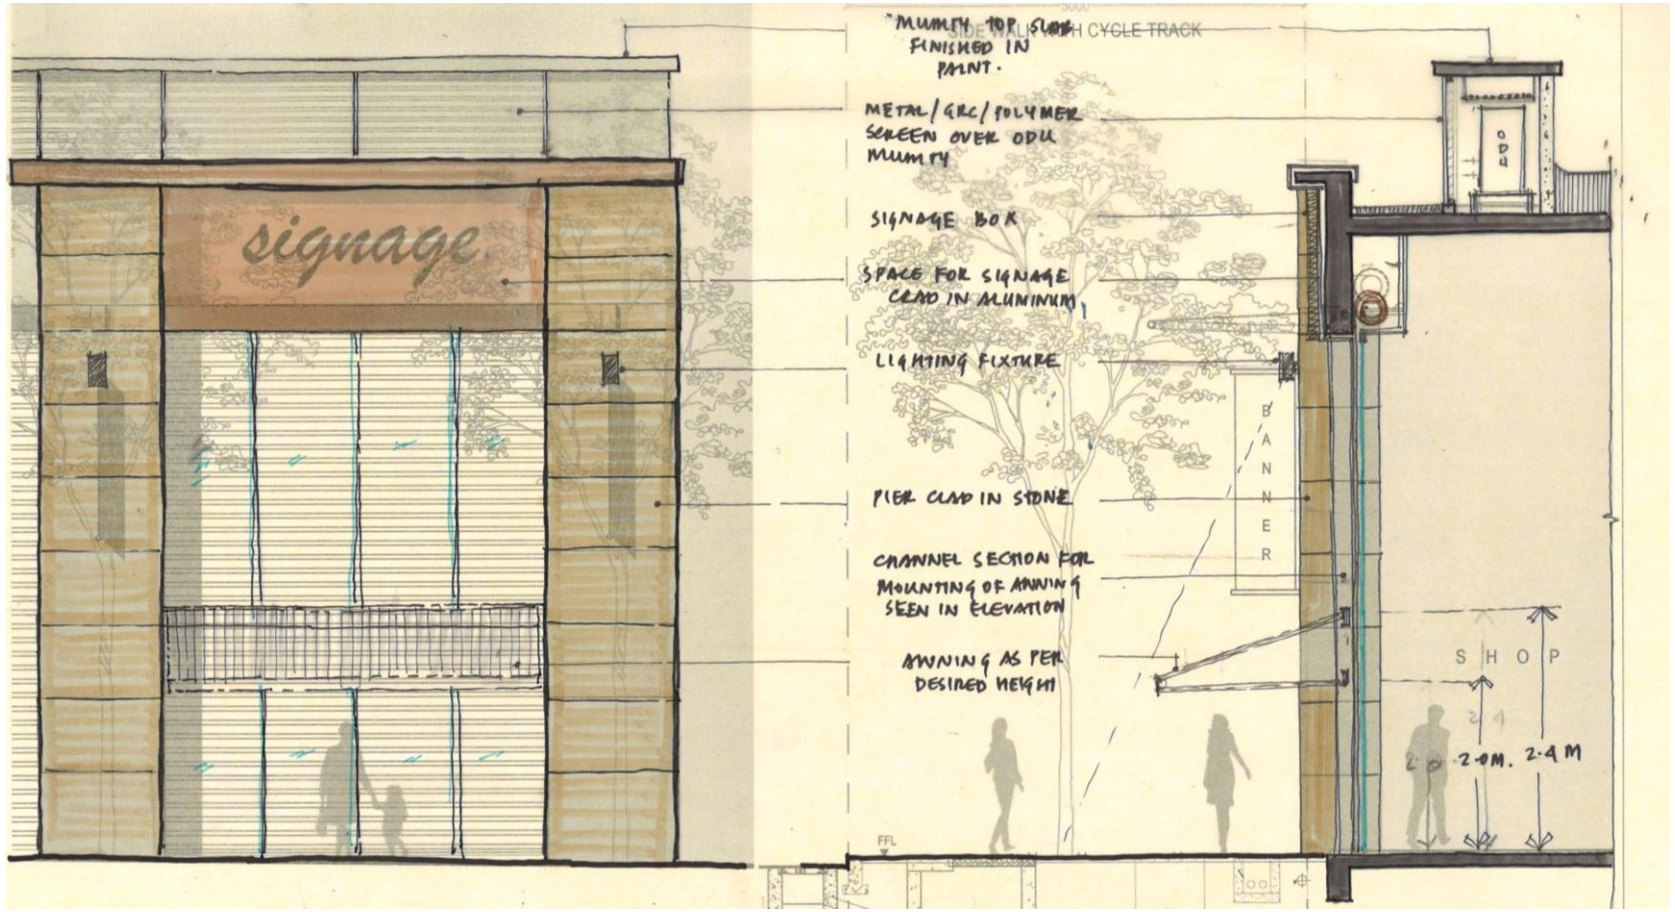
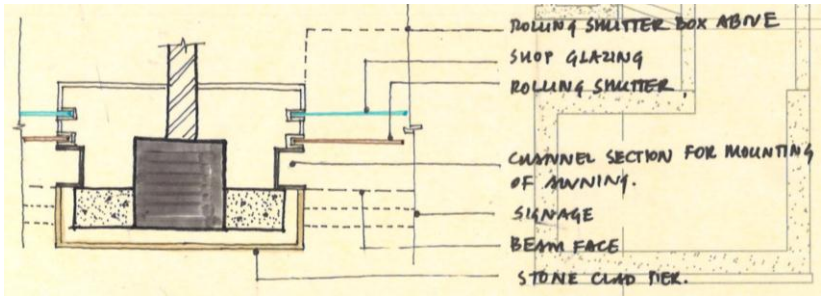
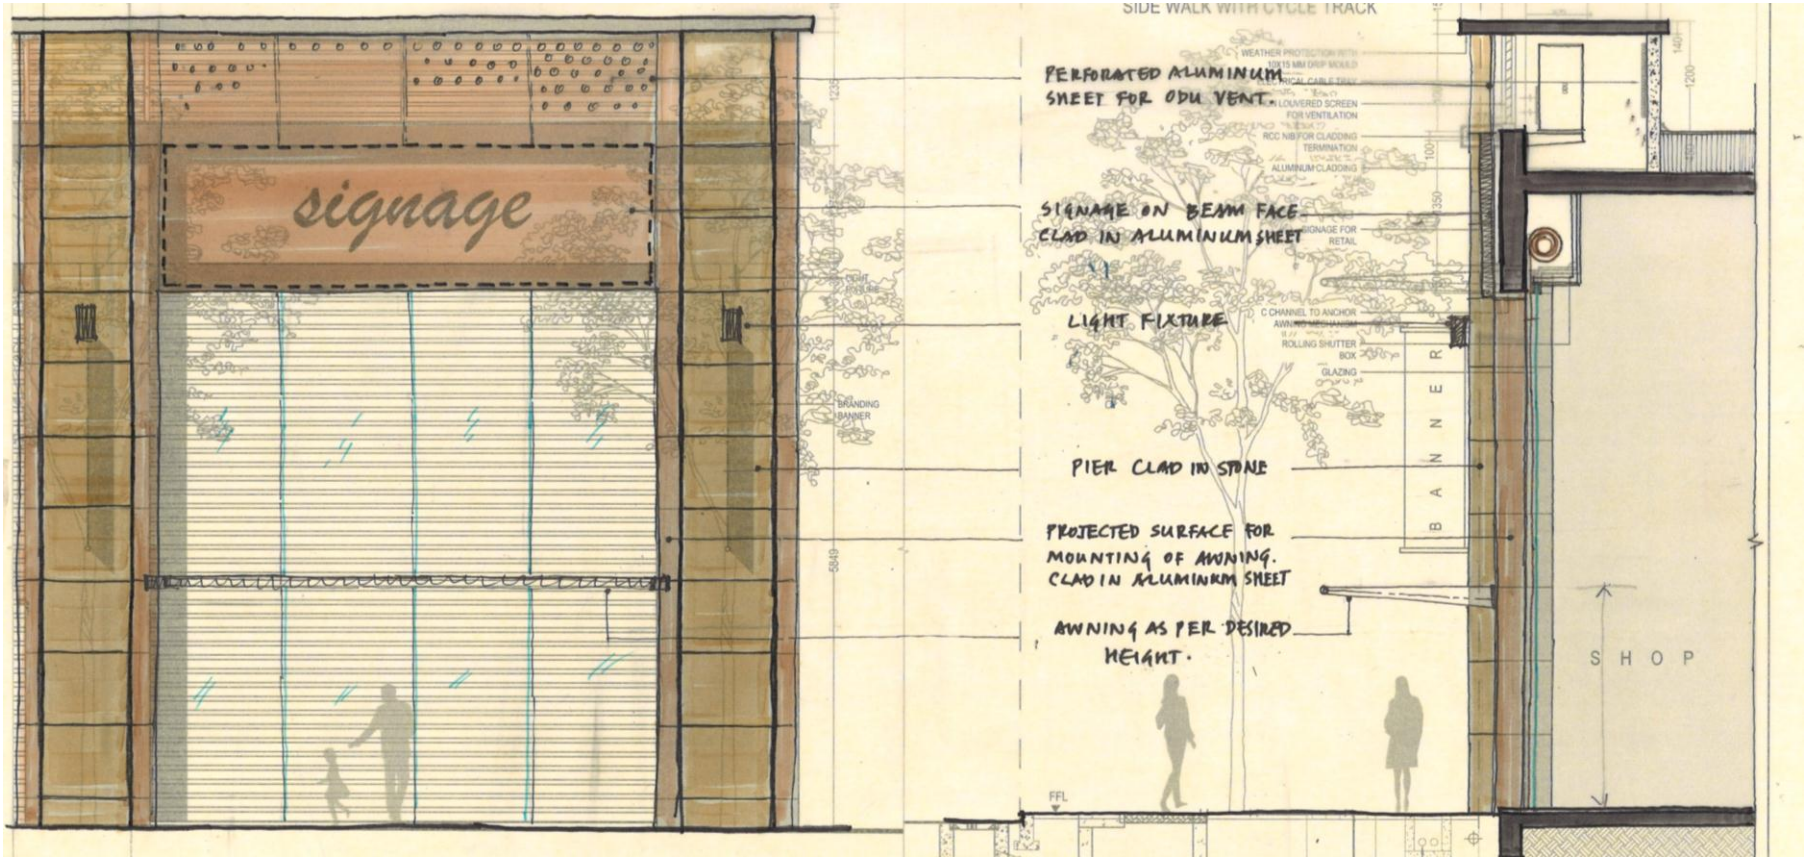
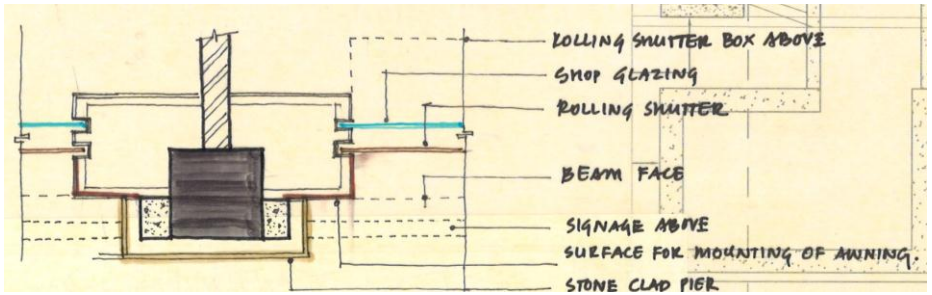
1. Retail edges of Casa Olivia and Florea to have a stepped ODU mumty section.
2. Horizontal louvers covering the ODU mumty can be substituted with a screen in GRC / FRP / Polymer etc.
3. Introduction of channel section to accommodate awning.
4. Detail gives flexibility on mounting height of awning.
